From: Fitzgerald, Conan <conan.fitzgerald@aecom.com>
Sent: Thursday, February 9, 2023 5:10 PM
To: Devlin, Cynde <devlincl@dhec.sc.gov>
Cc: Berresford, James <berresjl@dhec.sc.gov>; DiNardo, Paul M RTX <paul.dinardo@rtx.com>; McLeod, Todd <Todd.McLeod@delavan.com>; Ros, Ian <ian.ros@aecom.com>; Krouse, Caleb <caleb.krouse@aecom.com>; Zinna, Jasen <jasen.zinna@aecom.com>; Alexander, Leslee (Greenville) <Leslee.Alexander@aecom.com>
Subject: Revised On-Site Focused Feasibility Study - Delavan site

**Subject: Focused Feasibility Study and Response to Comments – Comment Letter dated December 1, 2022
Delavan Spray Technologies Site
Bamberg County
File #51778**

On-Site Focused Feasibility Study

Delavan Spray Technologies Site

SHEET TITLE
REMEDIAL ALTERNATIVE 5
CONCEPTUAL LAYOUT

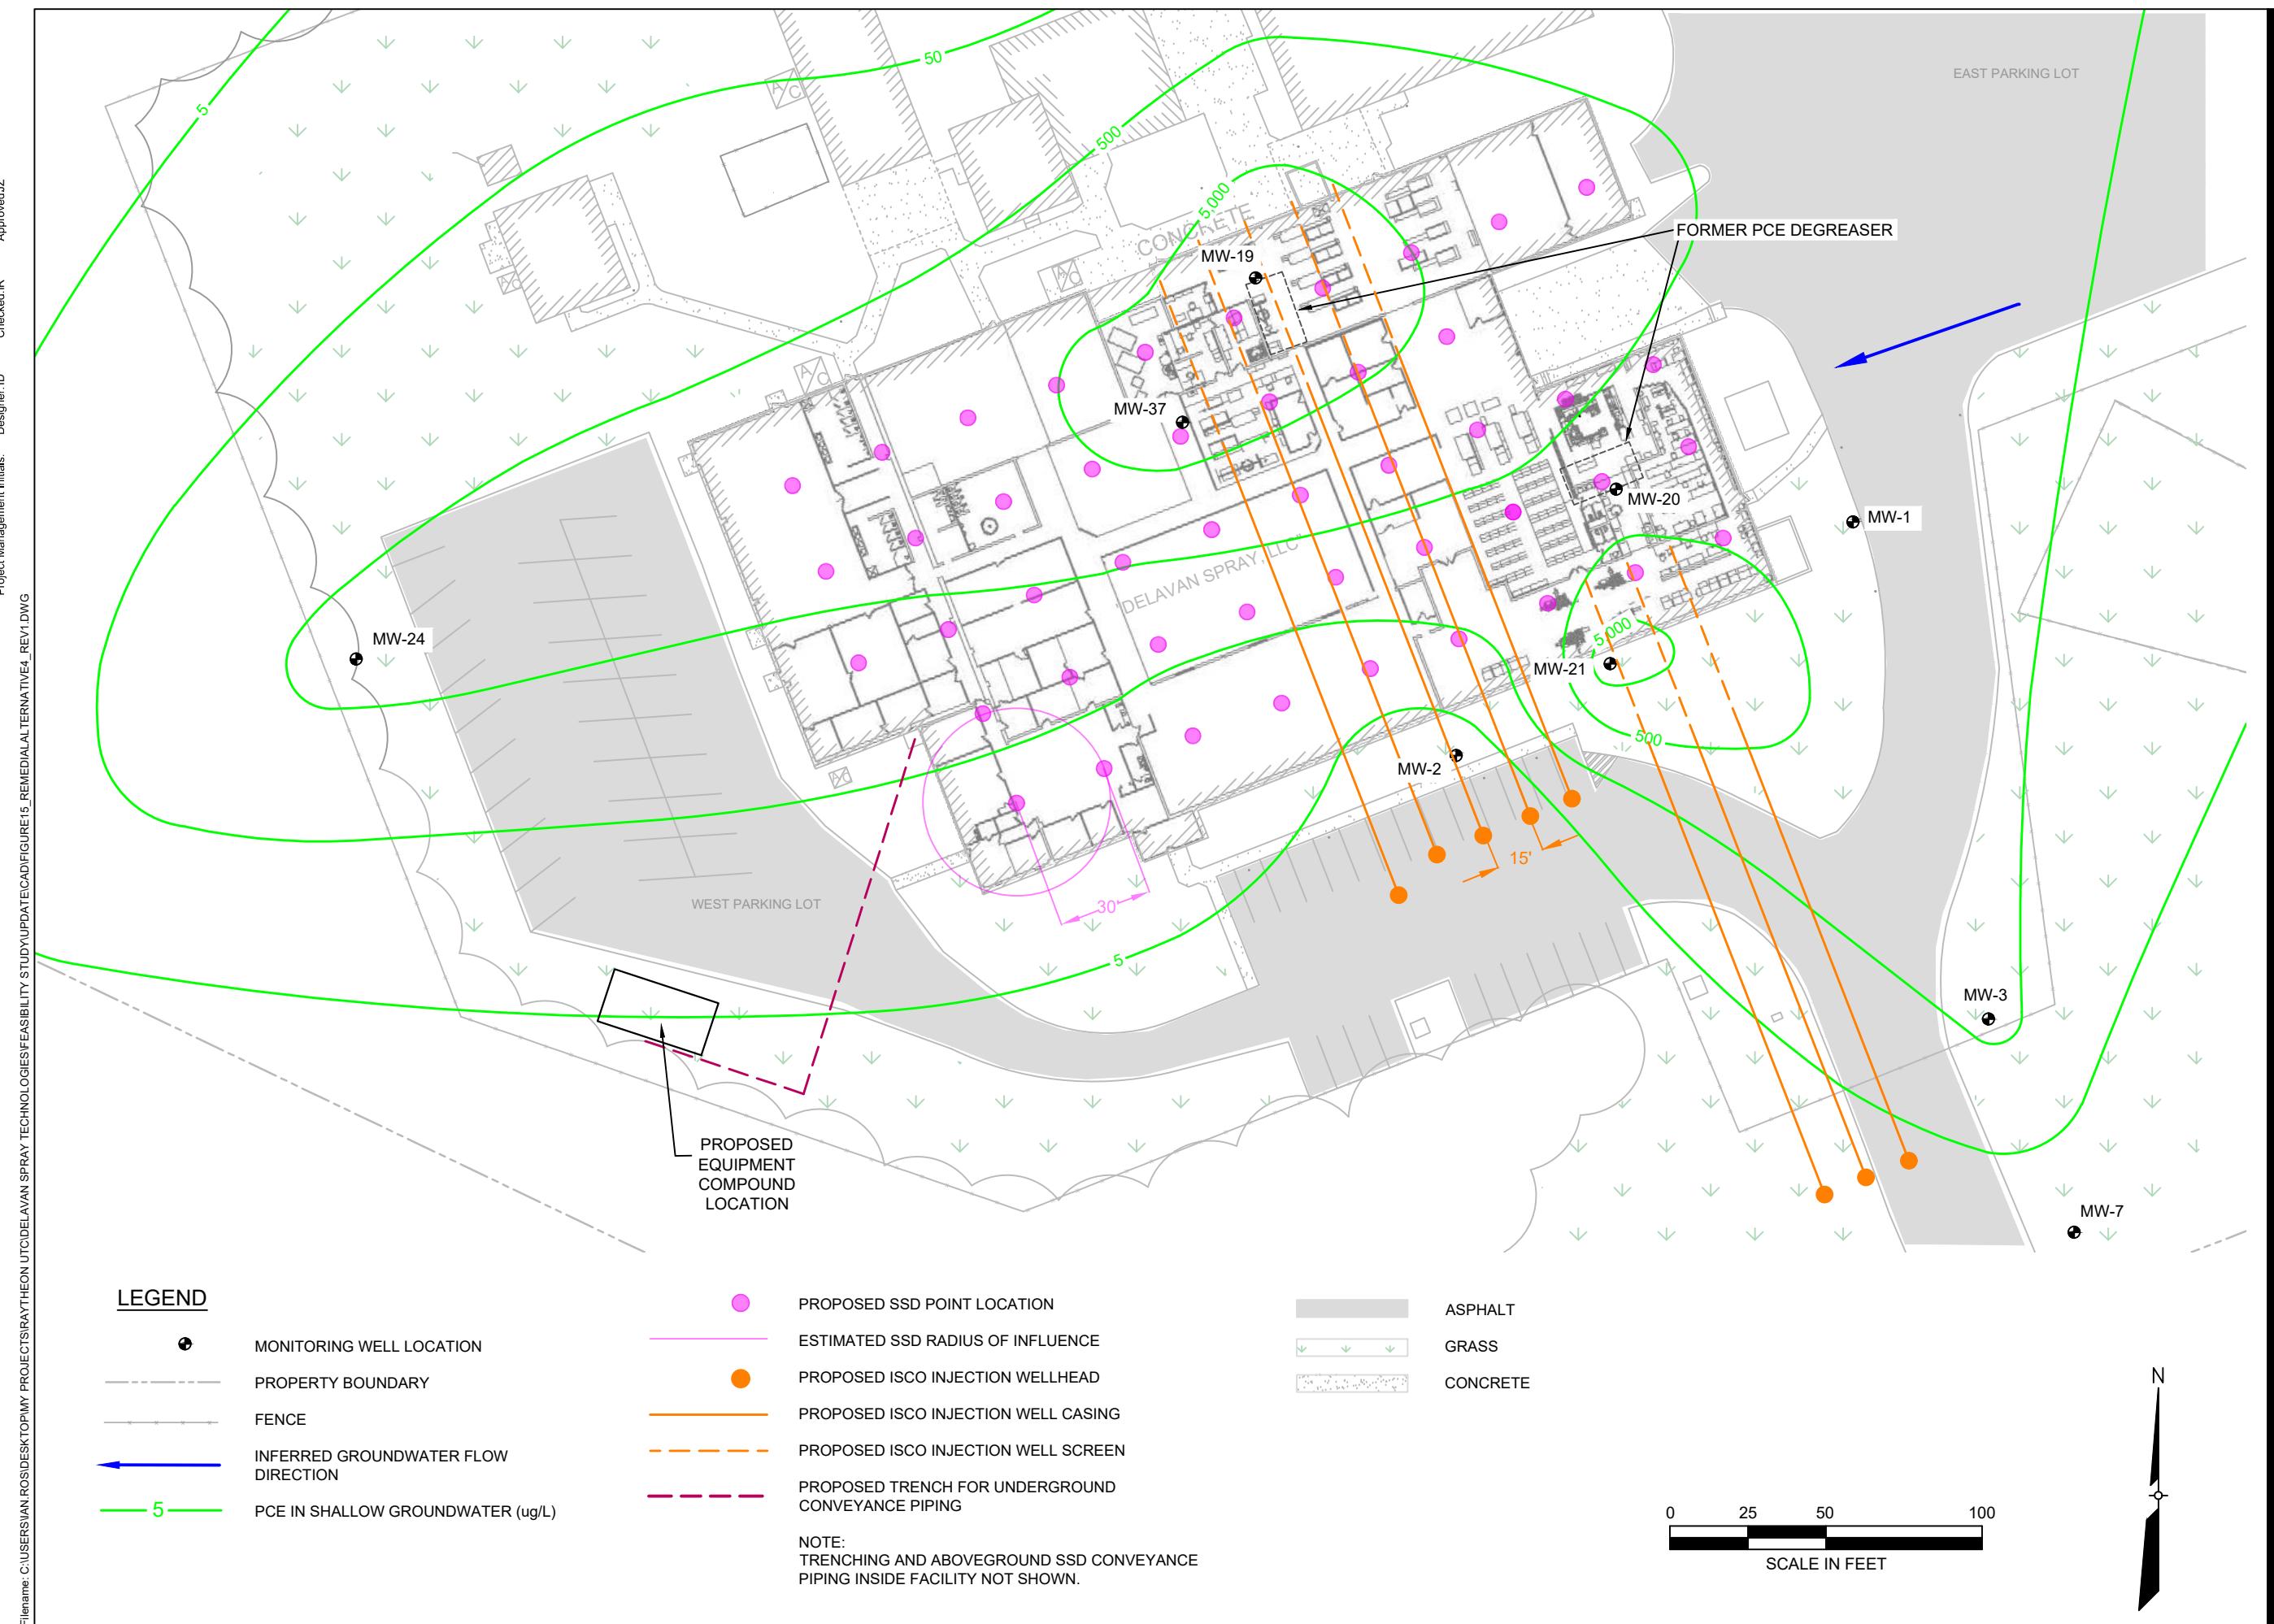
2. Revise the FS to include figures for each proposed remedial alternative. For example, figures for Alternative 2 would include the location of the proposed area of soil excavation, SSD system diagrams compared to soil contamination data and the location of extraction wells compared to groundwater contaminant concentrations.

- Added Figure 15 to show conceptual layout of Remedial Alternative 4. The ISCO injection well locations are based on MIP data, saturated soil sample results, and elevated shallow groundwater impacts (see Figure 8 and Figure 9).
- For Figures 13, 14, and 15, the SSD points cover the entire main facility building footprint due to potential vapor intrusion from impacted groundwater.
- Added Figure 16 to show conceptual layout of Remedial Alternative 5. SVE well locations represent the approximate as-built configuration. The AS/SVE well locations are based on MIP data, unsaturated soil sample results, saturated soil sample results, and elevated shallow groundwater impacts (see Figure 7, Figure 8, and Figure 9) and are intended to sufficiently eliminate impacts below the main facility building such that SSD is not necessary.
